THE STATE OF SOUTH CAROLINA
In The Court of Appeals

Builders FirstSource-Southeast Group, LLC, ...

RECORD ON APPEAL
VOLUME X

RCG File No: 44200935

Photograph 7

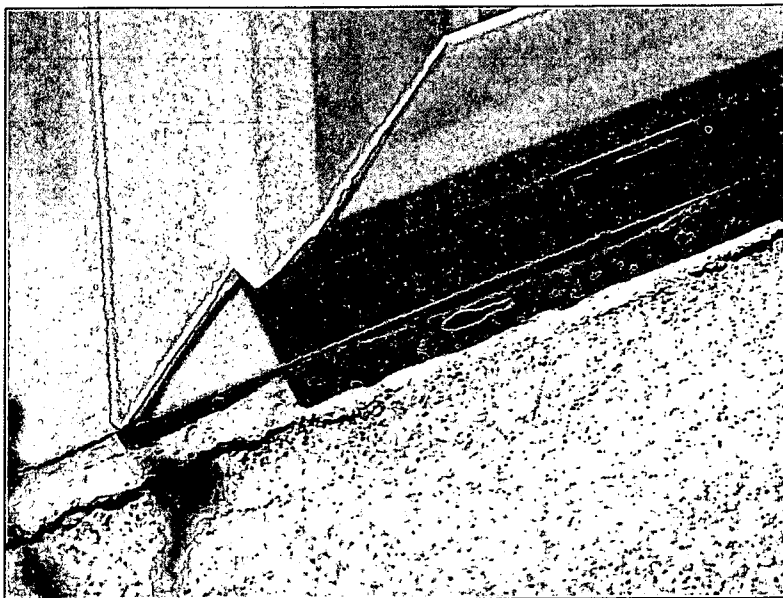
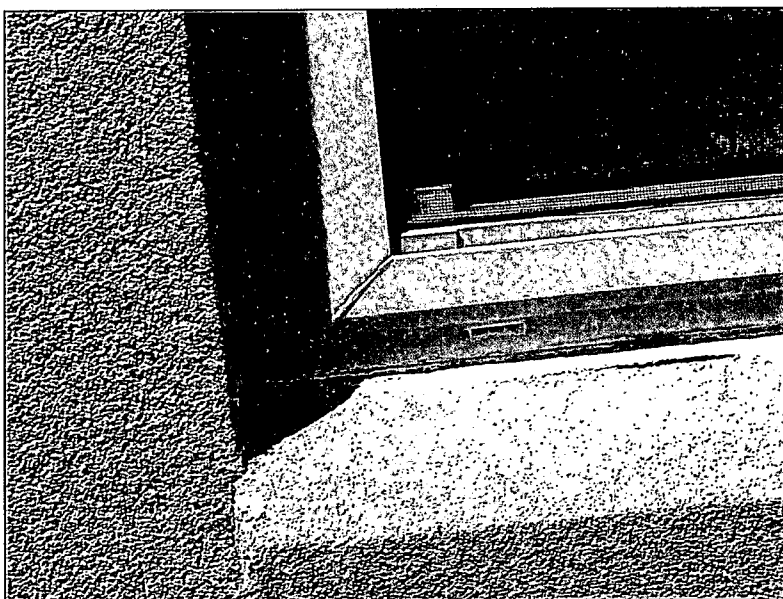
The moisture damage below the windows was attributable to separations in the caulk and the inadequate maintenance of the separations. As indicated in "Caulking" subsection (Section 5, page 13) of the *One Belle Hall Homeowner's Manual and Warranty Book*, the exterior caulking required routine maintenance, "or wood rot could be expected." The WDP report did not provide any evidence that the caulk deterioration and separations were the result of construction defects.

Photograph 11

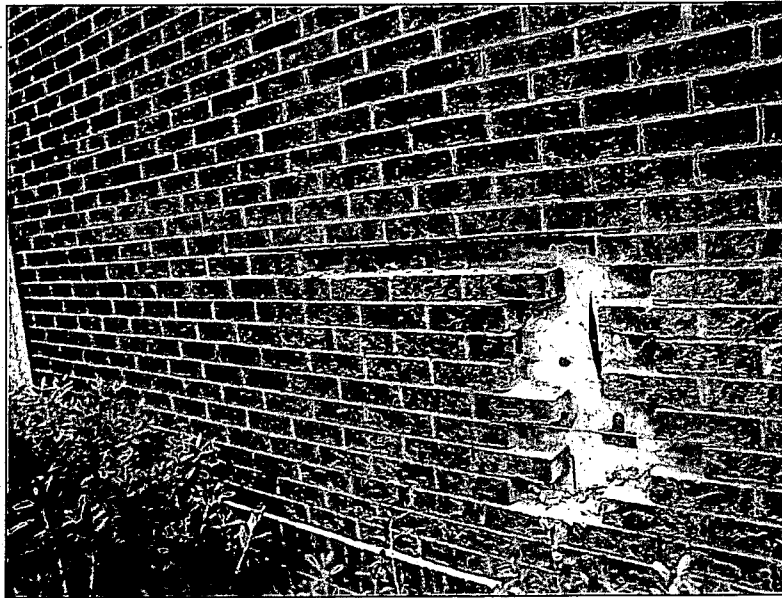
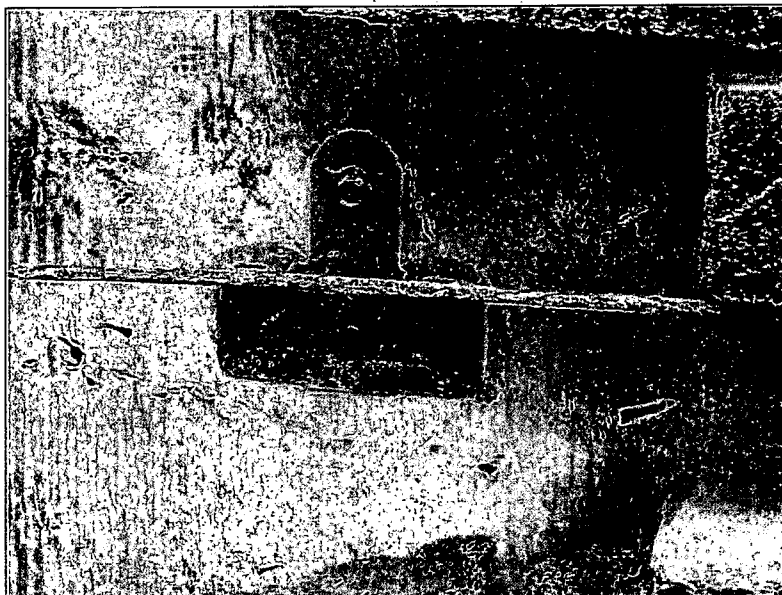
Allegation 3.1.2.7: "The wall ties were double eye and pintle type ties, made similar to Dur-a-Wal's [sic] DA 213 [HD-213] with seismic joint reinforcing included. This brand and type of wall tie was not what was specified. Hohmann and Barnard DW10X [sic] with seismic clips were required by the plans and specifications."

Response: The DW-10-X anchor noted by WDP was intended for installations where an exterior insulation board was present. The Project Manual specifications did not require the use of DW-10-X. Up to 24 feet above the floor level, Section 04200-2.05.A of the specifications permitted the use of CWT corrugated anchors by Hohmann and Barnard or approved equal. Above 24 feet, the specifications required DW-10HS by Hohmann and Barnard or approved equal. There was no evidence to indicate that the substituted wall ties were not approved for use, or did not comply with code requirements (**Photographs 11 & 12**).

Photograph 13
Typical wind-brick sealant application.

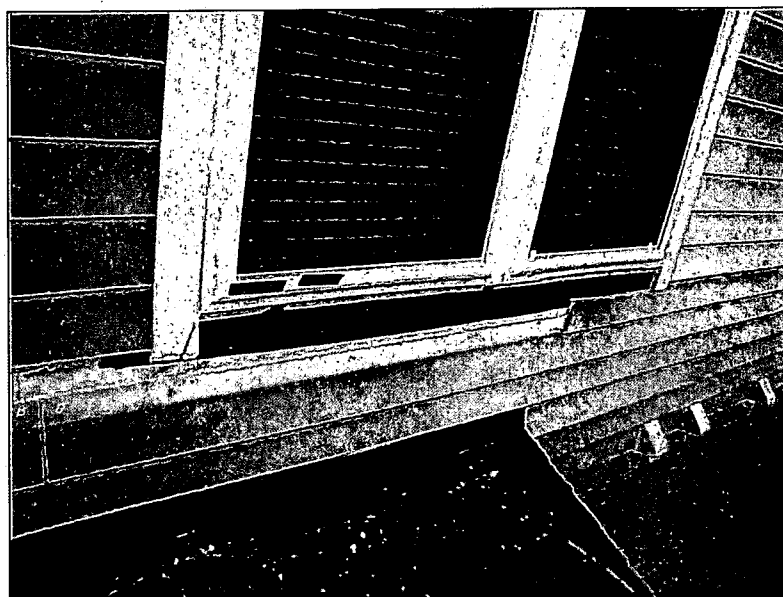
Allegation 3.1.2.12: "Perimeter sealant joints between the brick veneer and the windows were caulked without use of backer rods as required in the plans and specifications."

Response: The Project Manual specifications did not require the use of a backer rod at all joint locations. While a backer rod was commonly depicted on the construction drawings, typical silicone acrylic latex sealants that were approved for use on the project, such as Dow Corning 795, do not require the use of a backer rod in all locations. The WDP report was inaccurate, and did not support the allegation that the omission of a backer rod was a construction defect. (Photograph 13)

Photograph 20
A 17-inch long lap at the flashing above the garage roofing.

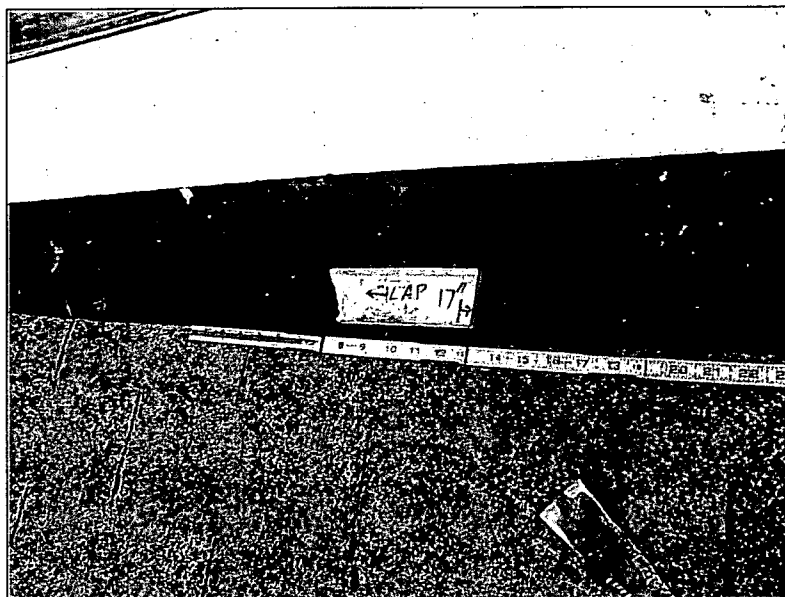
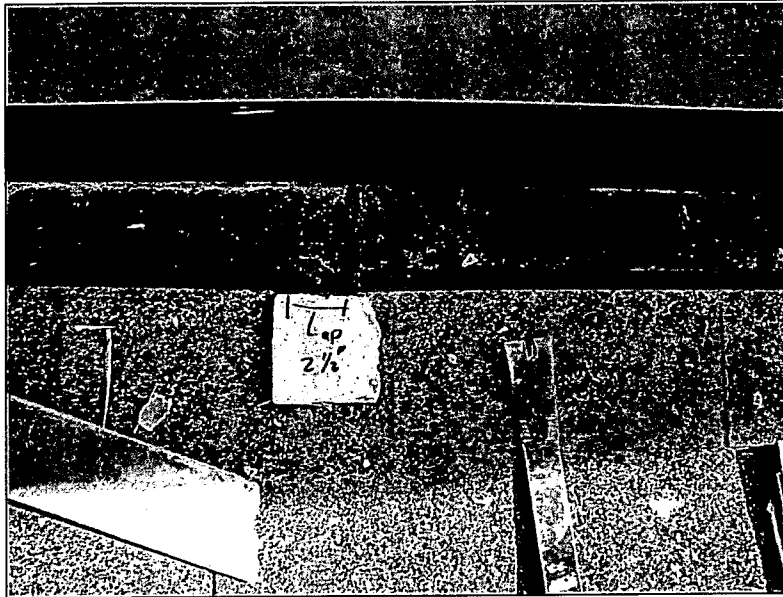
Response: During inspections, three randomly chosen headwall flashings at the upper slope of the first level roofs (over the garages) were inspected. All of the overlaps exceeded the National Roofing Contractors Association (NRCA) recommended minimum overlap of 2 inches (2013, Detail ASPH-11) (**Photographs 20 & 21**). The documented "short" overlap by WDP constituted a construction defect, but was not a typical condition.

Repairs: The base flashing at the garage roofs shall be inspected to verify overlap conditions meet or exceed 2 inches. Any overlaps that

Photograph 22

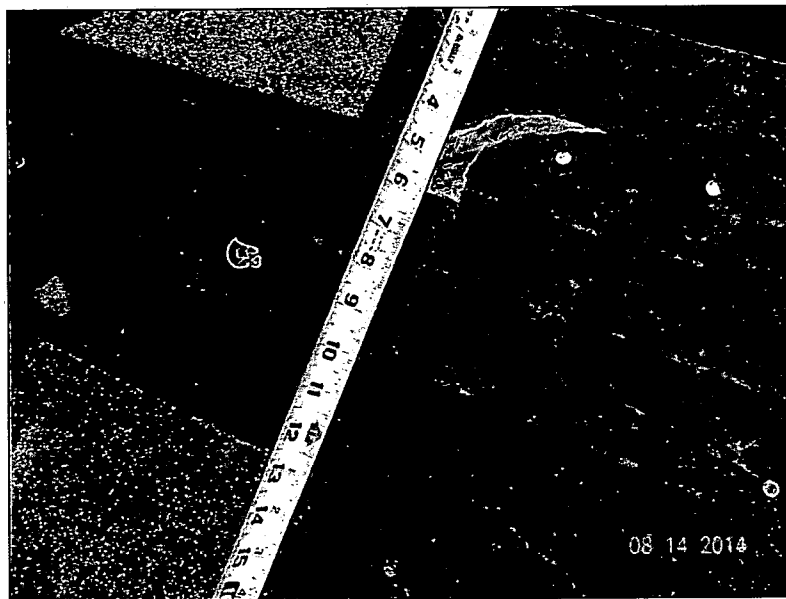
Response: Subsequent inspections by Rimkus Consulting Group, Inc. did not reveal conditions reflective of those reported by WDP (Photograph 22). While the WDP inspection did reveal isolated areas where the overlap did not comply with the underlayment manufacturer installation instructions, there was no evidence of resulting damage from these conditions.
